Reference: RFP #735-17-8178 Hampstead Parking Lot Construction

This letter serves as addendum one (1) to the above referenced RFP.

4605 OLD JACKSBORO HIGHWAY HONE (940)723-1455 WICHITA FALLS, TEXAS 76302 FAX (940)397-0549 SCALE: 1" = 20' SHEET 2 OF 7 MARCH, 2017

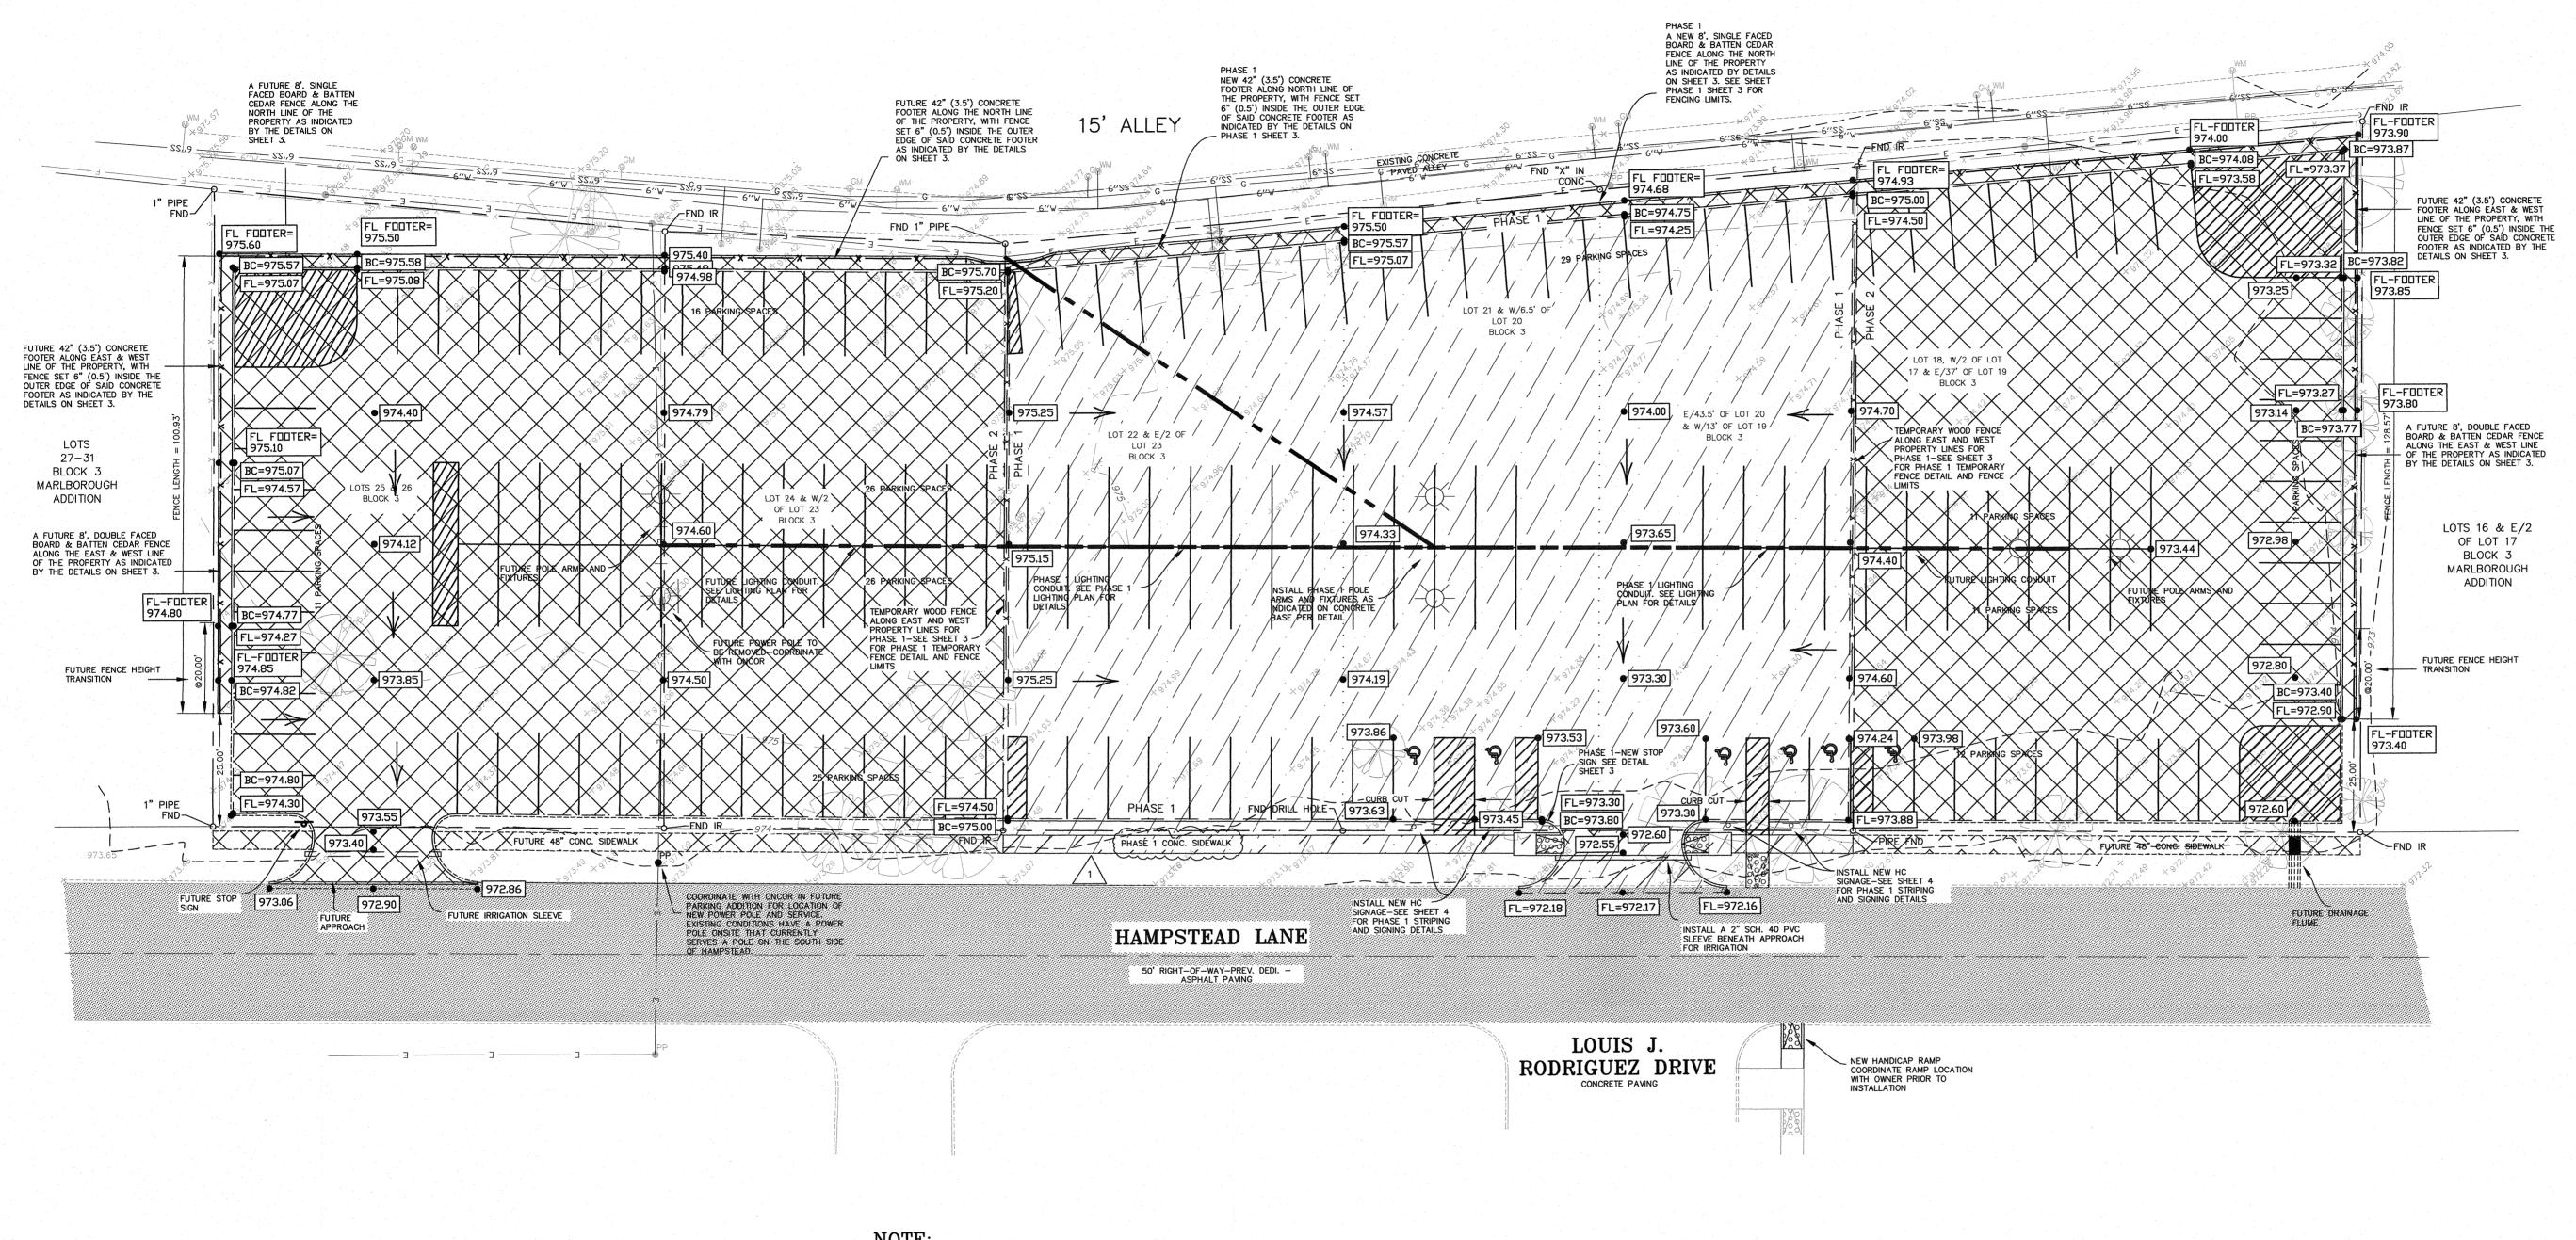
- 3. The original sheet 2 included a note about the future sidewalk on the south side of the new parking lot. Sheet 3 references the sidewalk as part of the project. The note on sheet 2 has been corrected (attached); the sidewalk on the south side of the new parking lot IS part of the Phase 1 scope of work.

3/31/2017 - PHASE 1 SIDEWALK LIMITS CLARIFIED

3/31/2017 - "FUTURE 48" CONC. SIDEWALK" TEXT CHANGED TO "PHASE 1 CONC. SIDEWALK"

3/31/2017 - ADDED HANDICAP RAMP AT INTERSECTION OF HAMPSTEAD LAND AND LOUIS J. RODRIGUEZ DRIVE
